ITEM FOR ENVIRONMENTAL COMMISSION AGENDA

SUBJECT: Easton Park Section 2B
Case No. C8J-2015-0255.SH

On the April 5, 2017 agenda is a request for the consideration of a variance to allow fill up to 10 feet [LDC 30-5-341 and 30-5-342].

**RE: Easton Park Section 2B – Preliminary Plan
C8J-2015-0255.SH
Fill Variance**

CUT/FILL EXHIBIT - MINUS R.O.W

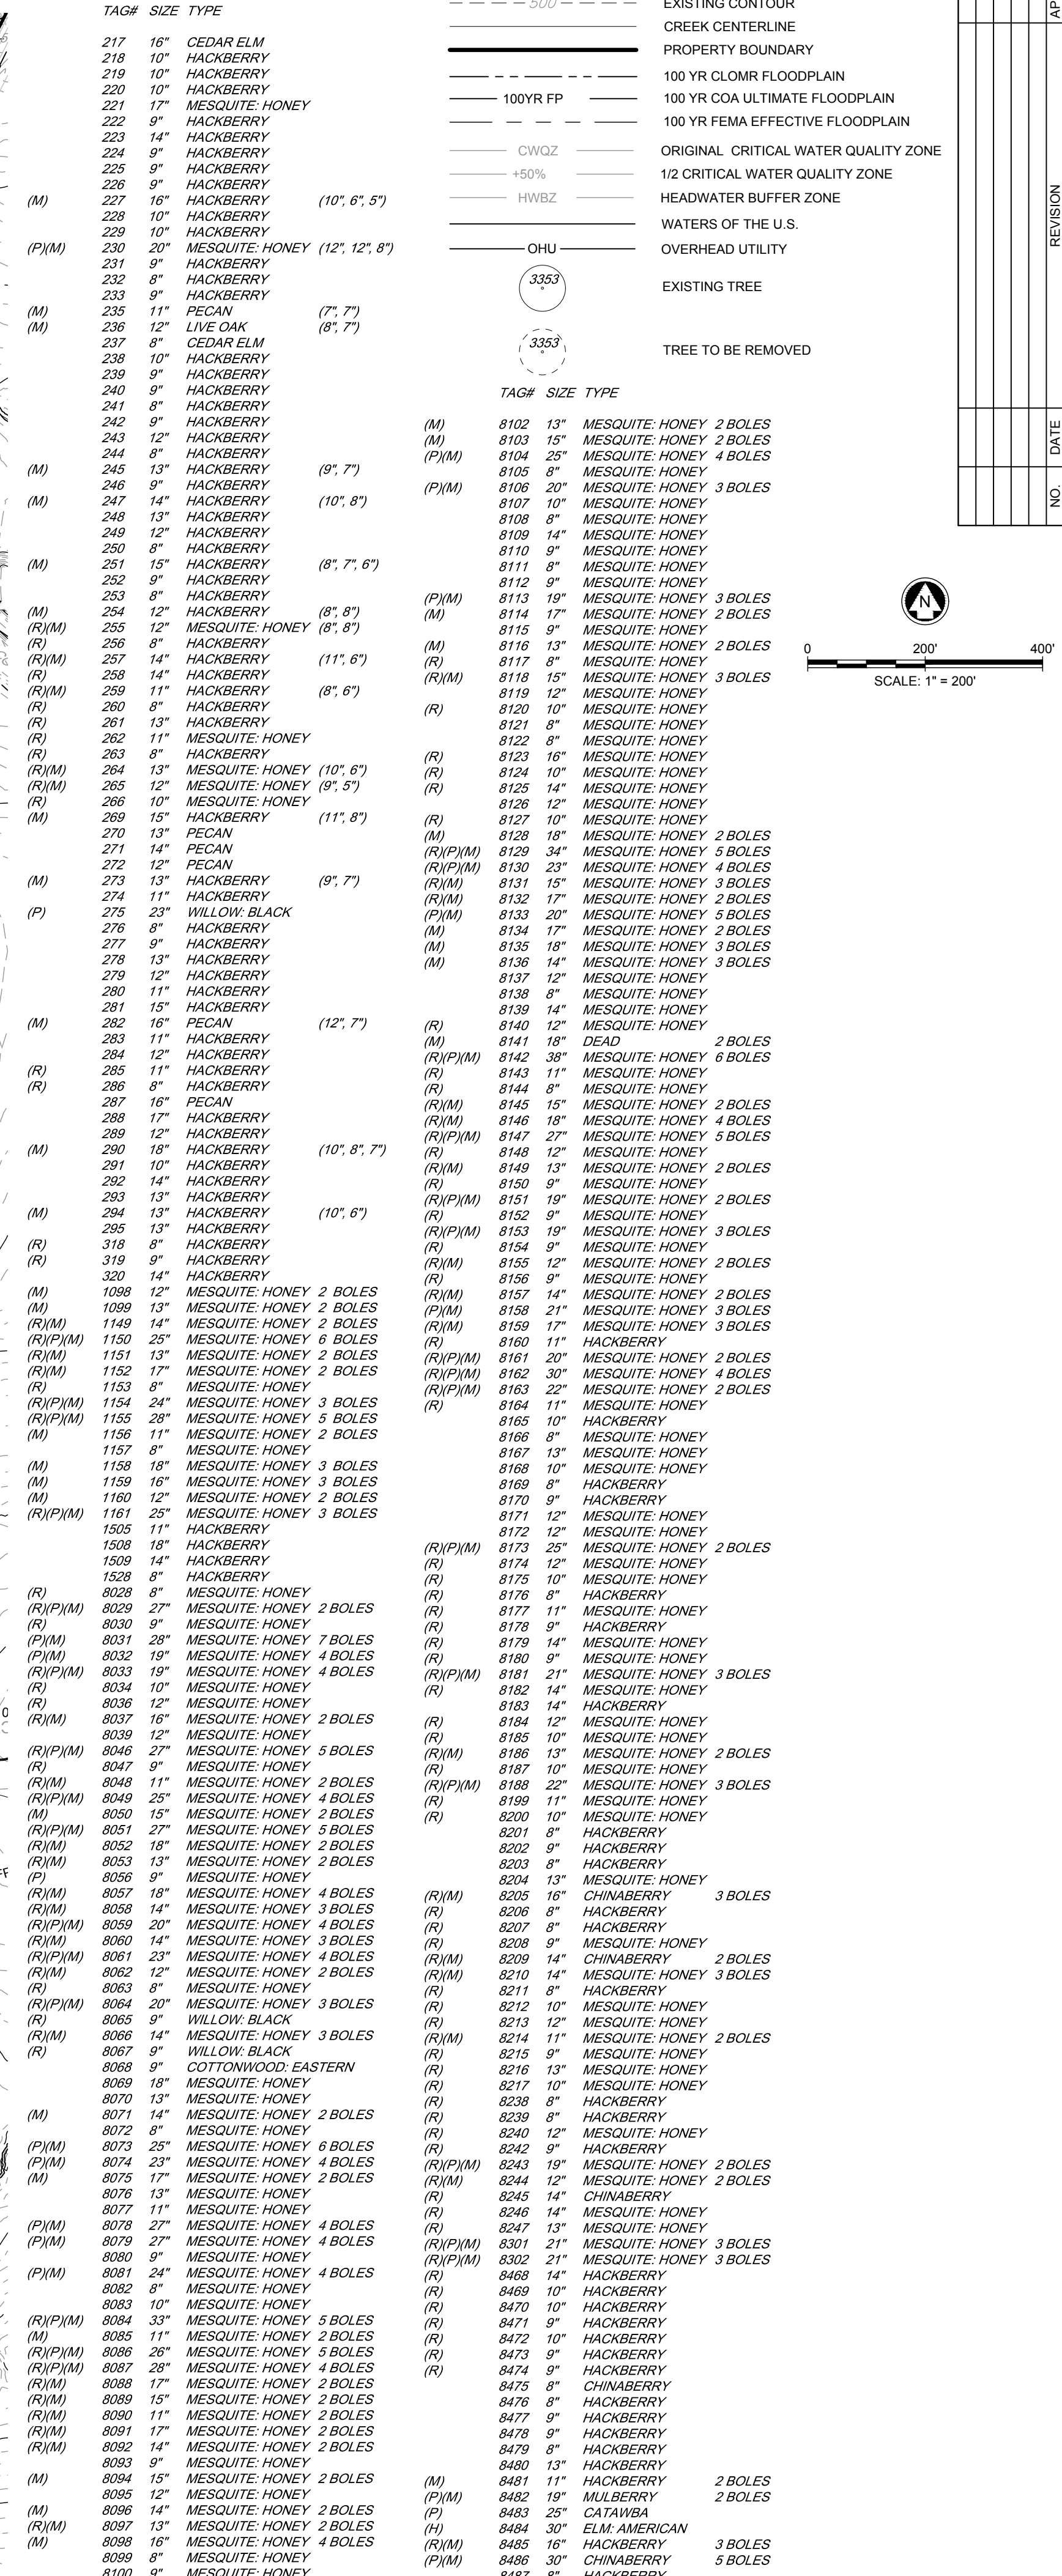
Clearly indicate in what way the proposed project does not comply with current Code (include maps and exhibits)	The development proposes fill greater than 8 feet. The maximum proposed is 9.6 feet. These are shown on the attached exhibit.
---	---
